To: T10 Technical Committee
From: Rob Elliott, HP (elliott@hp.com)
Date: 7 September 2004
Subject: 03-240r4 SAS-1.1 Internal wide connector and cable

Figure 1 — Internal wide connector plug picture (from Amphenol)

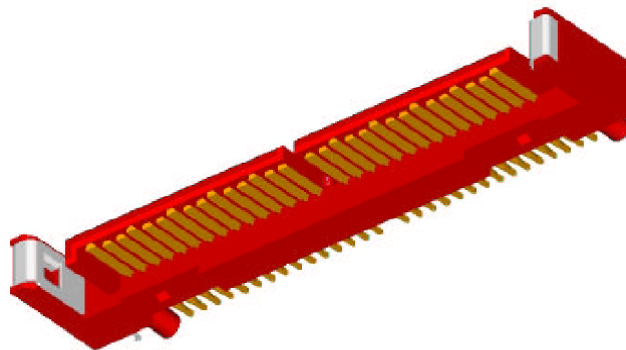
[Editor's Note 1: The connector ended up with 6 sidebands in the middle rather than 4 as shown.](#)

[Figure 2 — Internal wide cabled environment - controller to backplane - symmetric cable](#)

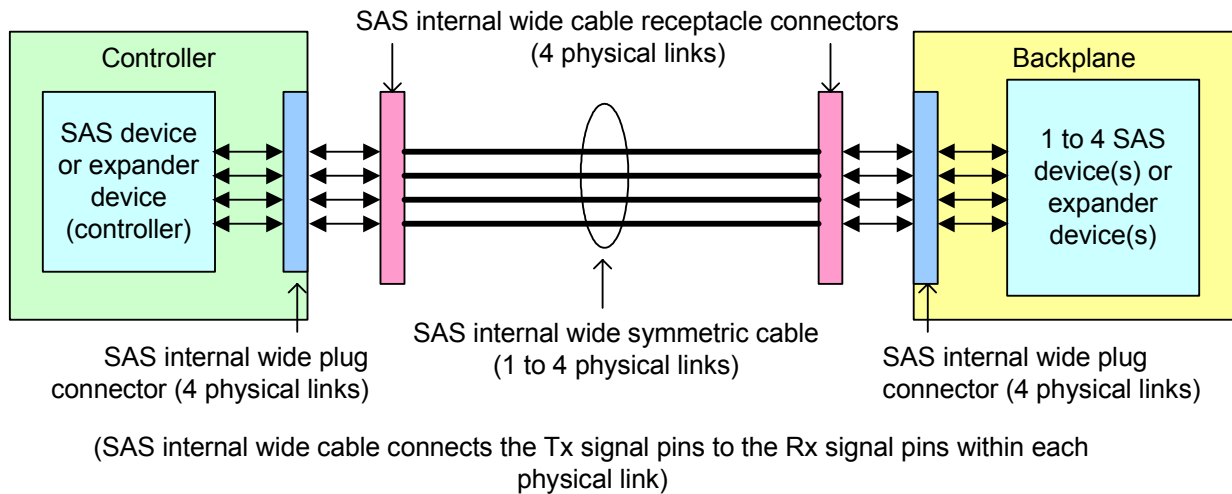
[Figure 2 shows a schematic representation of the cables and connectors defined in this standard for the internal wide cabled environment attaching a controller to a backplane using a symmetric cable.](#)

[The internal wide cable receptacle connectors have different pinouts for the controller end and the backplane end so one end's Tx signals are attached to the other end's Rx signals.](#)

[Figure 3 — Internal wide cabled environment - controller to controller - symmetric cable](#)

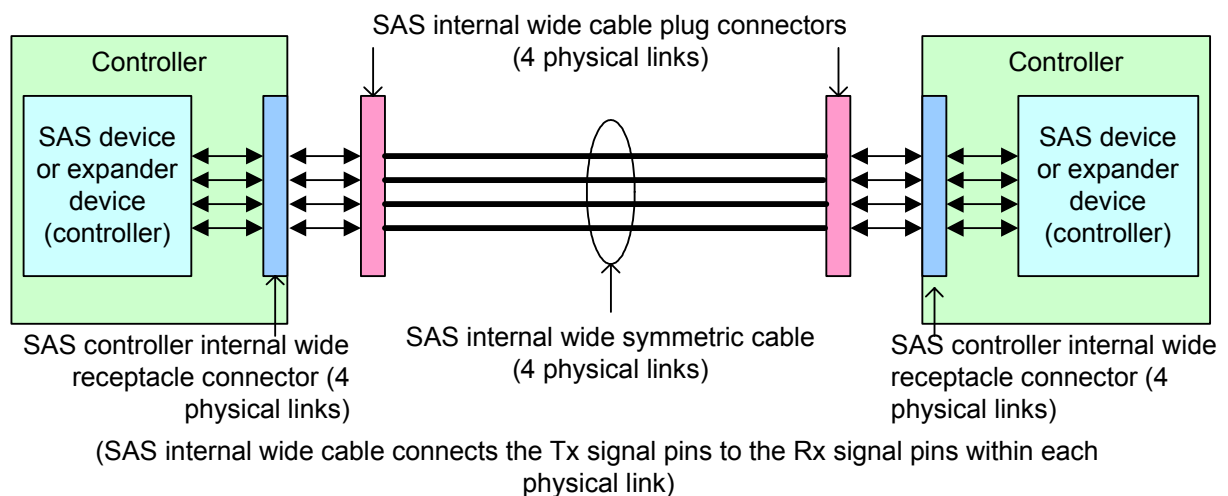
[Two controllers may also be attached together with a symmetric cable, provided all four physical links are used, since one end's physical link 0 is attached to the other end's physical link 3. Figure 3 shows the internal wide cabled environment attaching a controller to a controller using a symmetric cable.](#)

[The internal wide connector contains 6 sideband signals which are crossed when attaching a controller to a backplane but are not crossed when attaching a controller to a controller.](#)

[Figure 4 — Internal wide cabled environments with fanout cables](#)

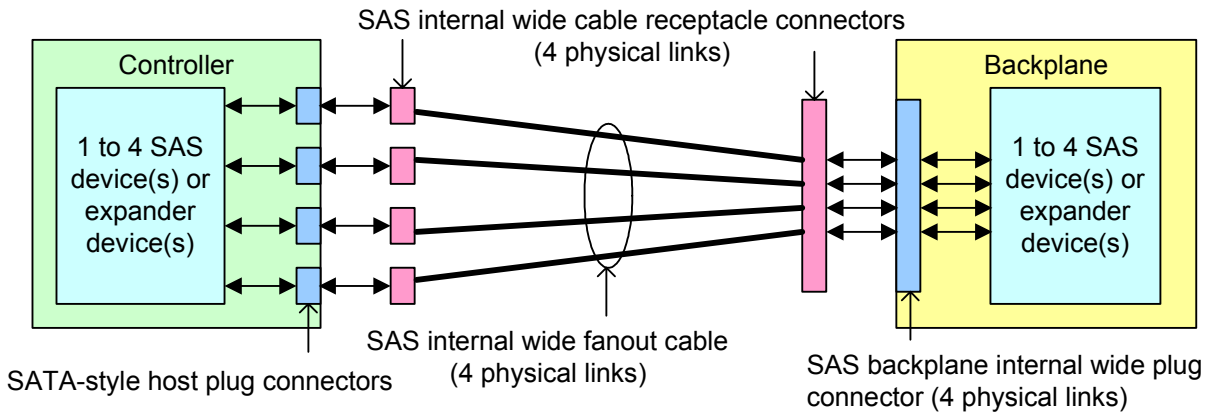
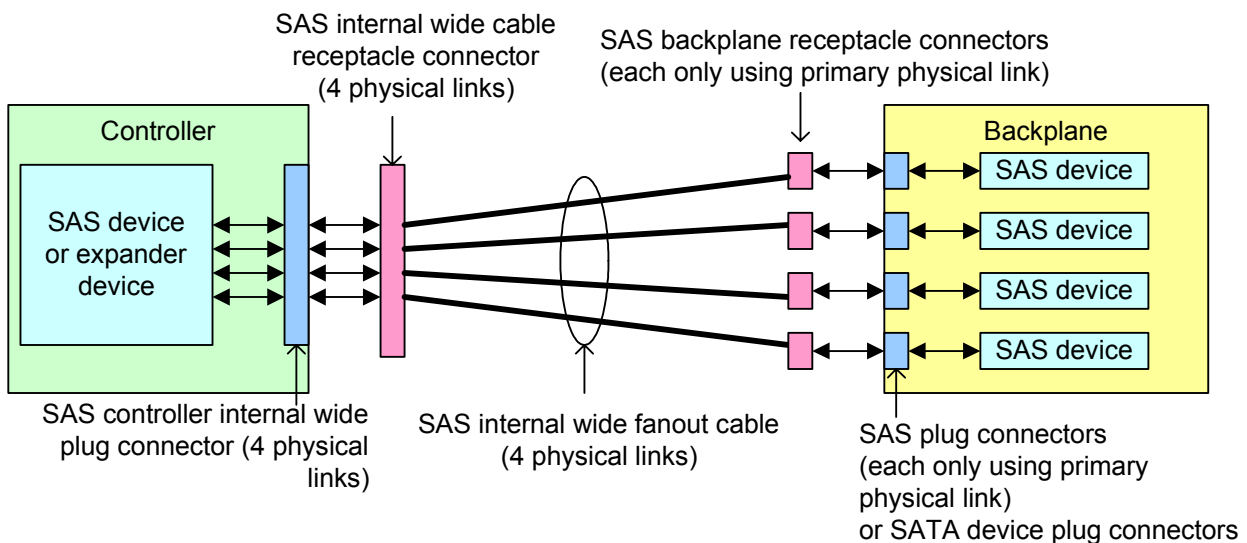
[Figure 4 shows a schematic representation of the cables and connectors defined in this standard for the internal wide cabled environments attaching controllers and backplanes using fanout cables.](#)

[Handling of the 6 sideband signals is vendor-specific in fanout cables.](#)
